RE: Case number 19-10 Valor Development, LLC Consolidated PUD Square 1499, Lots 802, 803, 806, and 807 Letter in Opposition

Figure 1

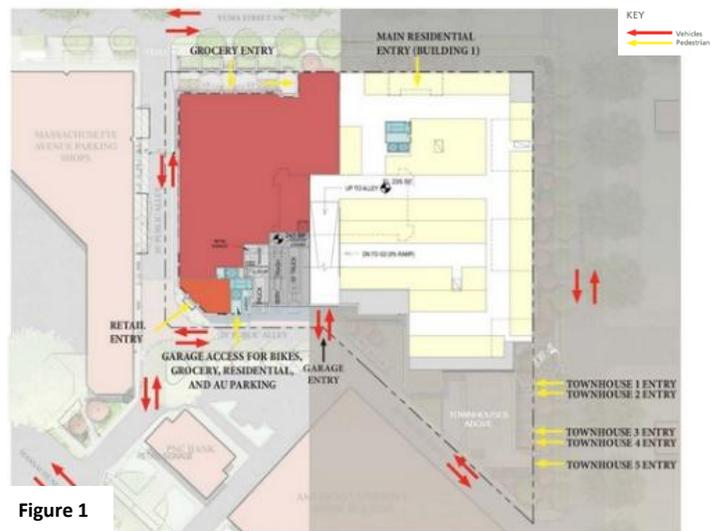
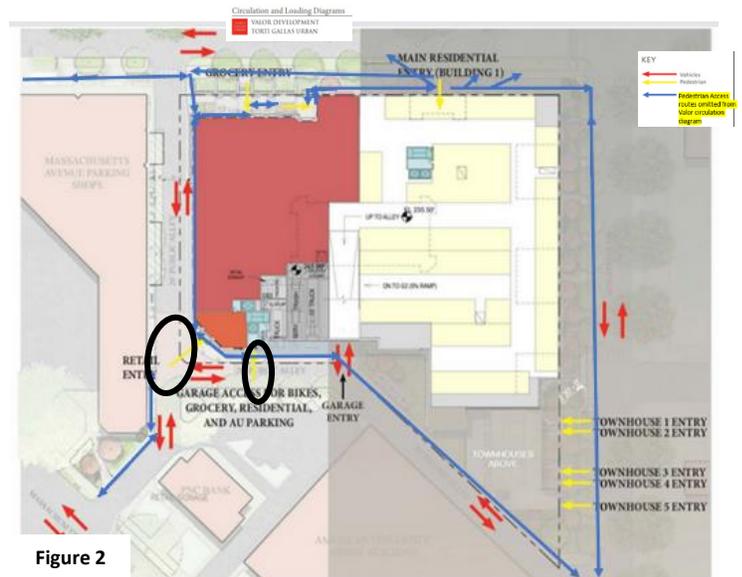
- Valor diagram CL01 (*Figure 1*) supposedly indicates pedestrian routes around the building. (Pedestrian access shown in yellow arrows.)

In fact, major pedestrian routes have been omitted from this diagram. I have added several (Figure 2) in blue.

The result of Valor's omission is that the viewer may fail to realize the severe pedestrian/vehicle conflicts I have indicated by black ovals. Both of these locations have pedestrians crossing not merely two-way traffic, as they would on a street, but diagonally across two-way traffic in which vehicles are moving both forward and backward (to access loading docks). These safety hazards are not consistent with the Mayor's Vision Zero program or, in fact, with common sense.

Figure 3

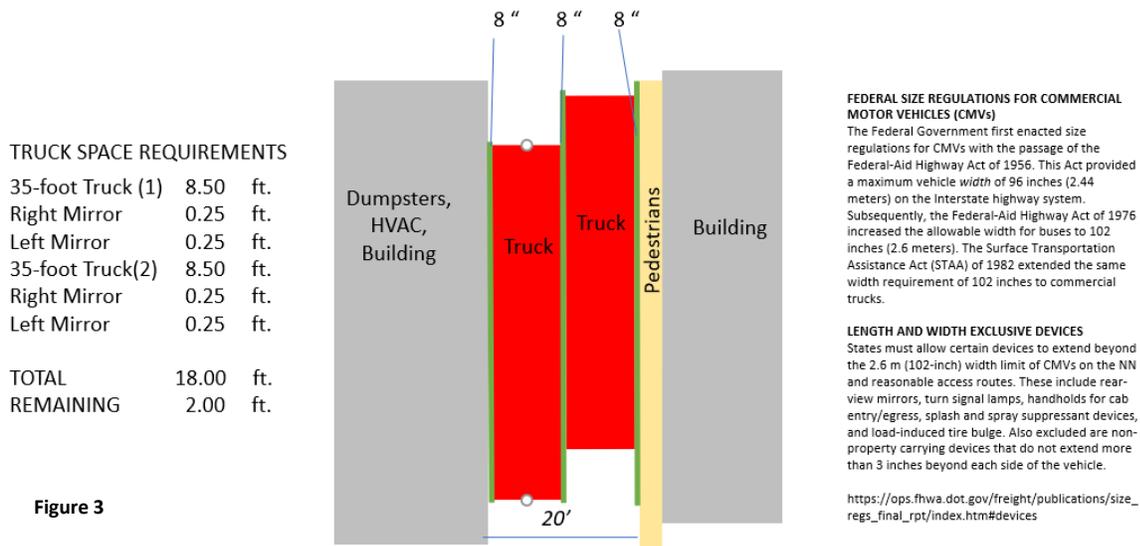
- Also contrary to common sense is the proposal to use a 20-foot alley as a two-way passage for trucks servicing the commercial buildings to the west of the proposed new building.

Using federal guidelines, we can anticipate that delivery trucks will be 8.5 feet (102 inches) wide in addition to having at least a three-inch allowance on each side for mirrors. Trying to fit two of these trucks side-by-side on a 20-foot alley gives trucks only 24 inches total between each other and the two structures on either side of the alley. The result is something like Figure 3:

Few if any truck drivers would attempt this risky maneuver.

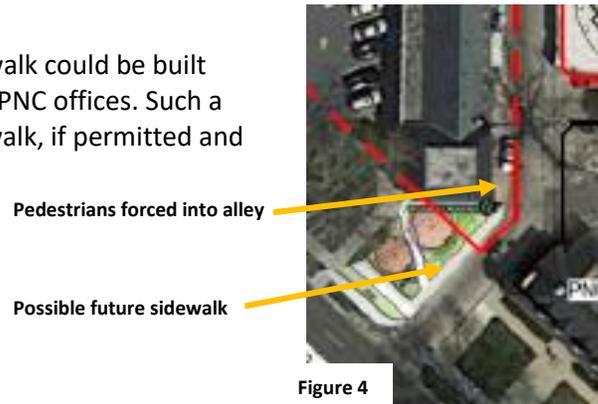
What are the alternatives? It's possible that two trucks might use the alley simultaneously to unload if one kindly pulled into the alley far enough to allow room for a second. But if the first truck is still unloading when the second is finished, the second is going to back up onto Yuma Street, where, in many circumstances, trucks may already be parked and waiting to unload while cars and buses attempt to pull around them and all attempt to avoid hitting parked cars. As a practical matter, truck drivers have little choice other than unloading on Yuma Street in even greater numbers than they already do, exacerbating an existing problem rather than alleviating it.

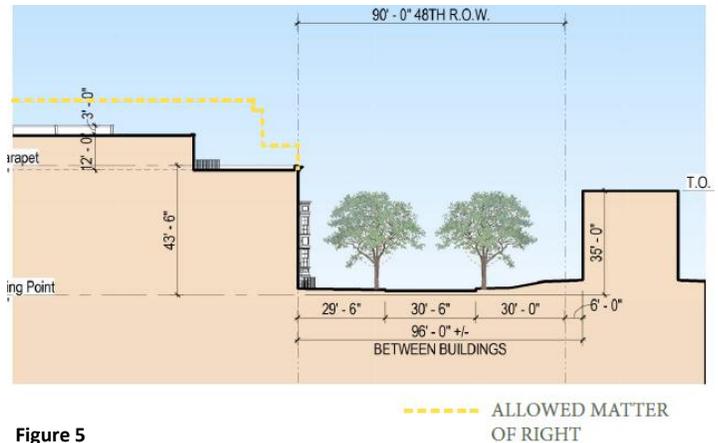
- Exhibits A26 through A31 (*Figure 5 is one example*) show six comparisons between the building being proposed and a claimed “allowed matter of right.” These exhibits give the impression that, at each diagram location, the proposed building is shorter than a building that *could* be built under “matter of right.” Whether or not this “matter of right” exists for *one* of these six locations, it cannot exist for all six. Under even the most permissive interpretation of “matter of right,” a building 50 feet high on one side and 80+ feet high on the other could not cover the entire site to the extent that the proposed building does. The “matter of right” permits only 185,000 square feet, not the much larger building that Valor proposes. To put this another way, under Valor’s interpretation of “matter of right,” a residential or commercial building of the height Valor proposes could exist on only part of the site and would have to be balanced by much shorter buildings or open space on other parts.
